Date: September 17, 2007
To: T10 Technical Committee
From: Alvin Cox (alvin.cox@seagate.com)
Subject: SAS-2 6Gbps PHY Electrical Specification

Abstract: The attached information defines the electrical requirements for 6 Gbps transmitter devices and receiver device. In addition, updates include reference transmitter and receiver device definitions to provide a means of determining if a channel is compliant and a cable specification section with requirements for 6Gbps usage. This proposal is a continuation of 07-063, at it ran out of revisions available.

Figure 118 — Transmitter device common mode voltage limit

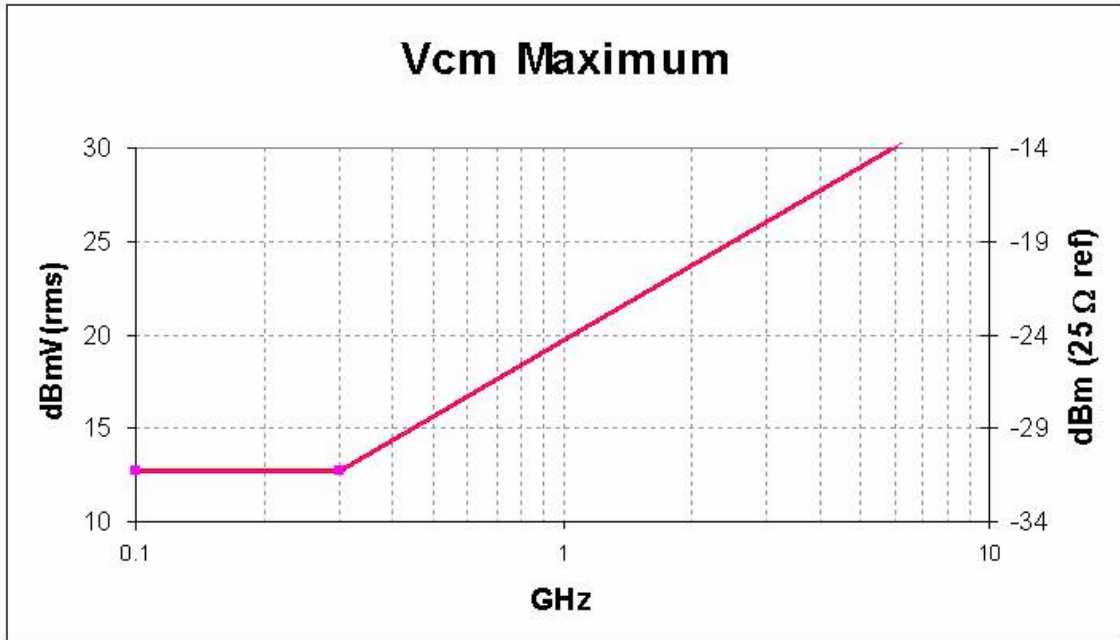
Flat line at 26 dBmV. No. Need more data.
 Range of 100 MHz to 6 GHz?
 What data pattern?
 Measured with 1 MHz bandwidth.

Figure 125 — Reference receiver device

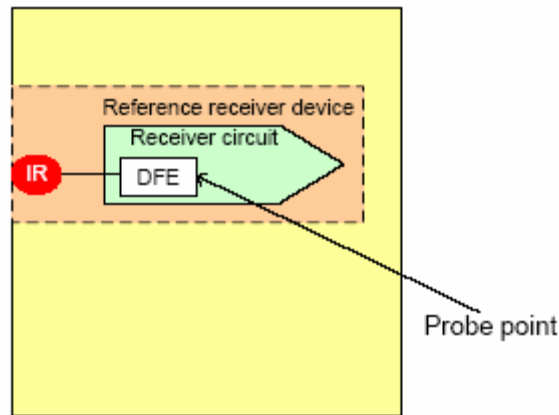
Need vertical and horizontal opening requirements to meet BER. Tbd and .4UI?
